Form 3160-3 FORM APPROVED OMB No. 1004-0137 (June 2015) Expires: January 31, 2018 **UNITED STATES** DEPARTMENT OF THE INTERIOR 5 Lease Serial No. NMNM102034 BUREAU OF LAND MANAGEMENT APPLICATION FOR PERMIT TO DRILL OR REENTER 6. If Indian, Allotee or Tribe Name 7. If Unit or CA Agreement, Name and No. **✓** DRILL REENTER 1a. Type of work: 1b. Type of Well: ✓ Oil Well Gas Well Other 8. Lease Name and Well No. 1c. Type of Completion: Hydraulic Fracturing ✓ Single Zone Multiple Zone STARK 33 FED COM 802H 2. Name of Operator 9. API Well No. 30**-0**15**-5**6636 EOG RESOURCES INCORPORATED 10. Field and Pool, or Exploratory 3a. Address 3b. Phone No. (include area code) PURPLE SAGE; WOLFCAMP (GAS) 1111 BAGBY SKY LOBBY 2, HOUSTON, TX 77002 (713) 651-7000 4. Location of Well (Report location clearly and in accordance with any State requirements.*) 11. Sec., T. R. M. or Blk. and Survey or Area SEC 33/T25S/R30E/NMP At surface TR M / 1181 FSL / 1258 FWL / LAT 32.082352 / LONG -103.890799 At proposed prod. zone TR N / 230 FNL / 1650 FWL / LAT 32.050516 / LONG -103.889557 12. County or Parish 14. Distance in miles and direction from nearest town or post office* 13 State **EDDY** NM 15. Distance

1181' FSL 1258' FWL Section 33 T-25-S, R-30-E **Proposed Wellbore Design B**

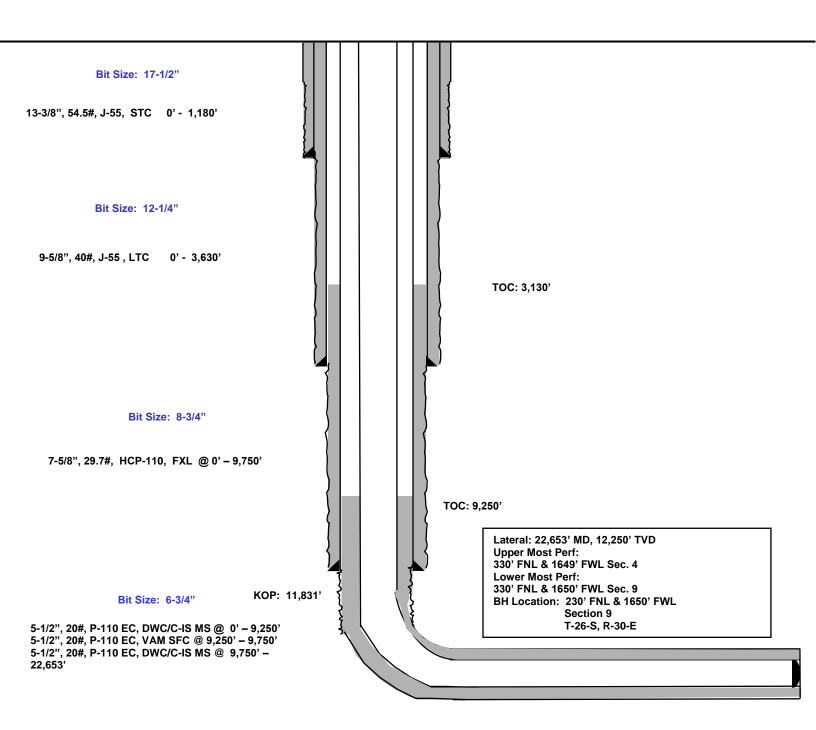
Operator is only approved for Design A. Design B is not to be utilized. If Design B is needed or any other change, please submit a NOI sundry to make the changes.
